Citizens' Oversight Projects (COPs)

August 30, 2018

The NRC announced a "Special Inspection" at San Onofre Nuclear Generating Station to review events surrounding the Aug 3, 2018, fuel-loading "near miss" incident. Through this letter we hope to provide guidance to this investigation by the NRC from our standpoint of providing public oversight, including a request for expanding the scope of your investigation. Please distribute this letter appropriately within the NRC so our concerns will be known by the inspection team.

Figure 1: Transporter lowering an MPC canister into an underground vault protected by Transfer Cask

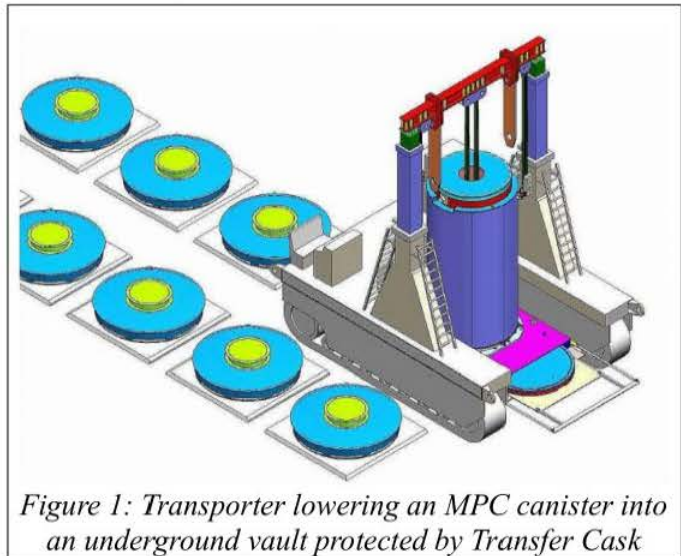
Once over the underground vault, the bottom of the transfer cask has a sliding door that can move out of the way so the MPC-37 canister can be lowered into the vault. (Figure 1).

Some have commented that there was no risk to the public in this near miss incident. We disagree. This event **could have been a major disaster**, and it is one that has not been adequately modeled nor is there any plan to deal with it.

Figure 2: Arrow shows location of alignment ring which was supporting the entire ~45 ton mass on about 1/4" from falling about 18 feet into the vault.

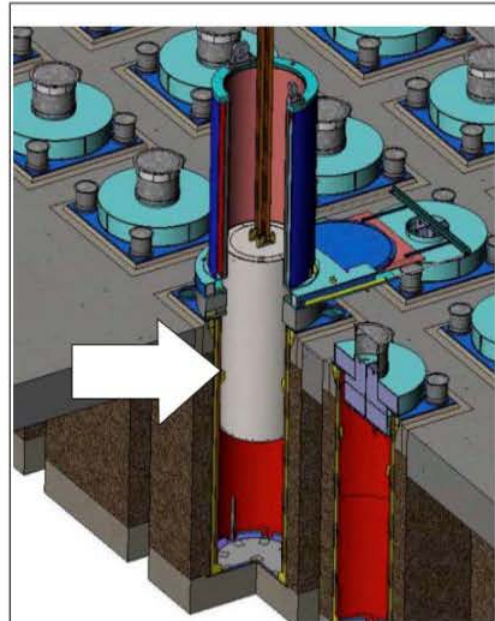
The rigging holding the canister lowered all the way, and workers thought the canister had successfully been lowered into the vault. However, the bottom of the canister had become lodged on the top of the MPC Guide Ring, which exists about four feet from the top of the vault, and the MPC canister was only barely held by about 1/4 inch from falling about 18 feet into the vault. (Figure 2).

Apparently, the workers then took radiation readings and were concerned that the readings were too high. They discovered that the canister was teetering on the alignment ring. They pulled the canister up with the rigging and re-centered it, and then successfully lowered it into the vault. Fritch also said that this was at least the second time such an incident occurred.

6. **REDESIGN:** Holtec should change their design of the spent fuel system so that:
 1. It is impossible for a canister get stuck in the lowering process
